Subject: Solar and battery farm, Land west of Ashwell Rd - NHDC ref 22/00741/FP

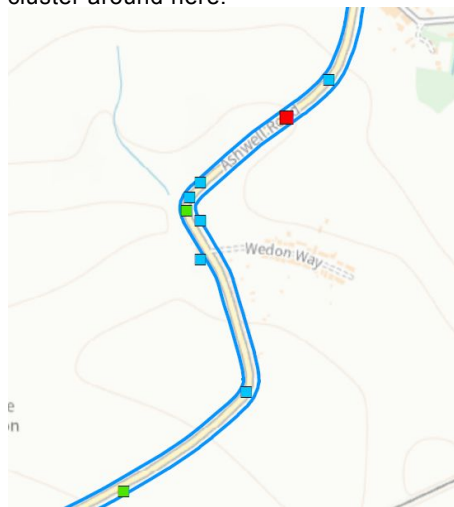
- We have thoroughly investigated accident history along the full stretch of Bygrave Road, going back to when our records started. There have been numerous accidents along the route over the years, however it's clear that most of these are driver error, involve alcohol/drugs, or in the case of pedestrians and cyclists, these have been very infrequent with no obvious pattern. What does stand out however are accidents at or on approach to bends where speed may have been issues, and there's a clear cluster around here:

Whilst accidents arising from speeding is still essentially driver error, the historic accident data implies that there is something more of a pattern and trend here, and it would seem reasonable to expect you to look into this specific section of the route in more detail, and propose measures. There are already some permanent warning signs around here, such as these:

Clearly we don't too want much in the way of sign clutter, but there might be additional signage such as 'pedestrians in road' that could help – please consider "The Traffic Signs Regulations and General Directions 2016" as a starting point, but there may be other options beyond signage too.
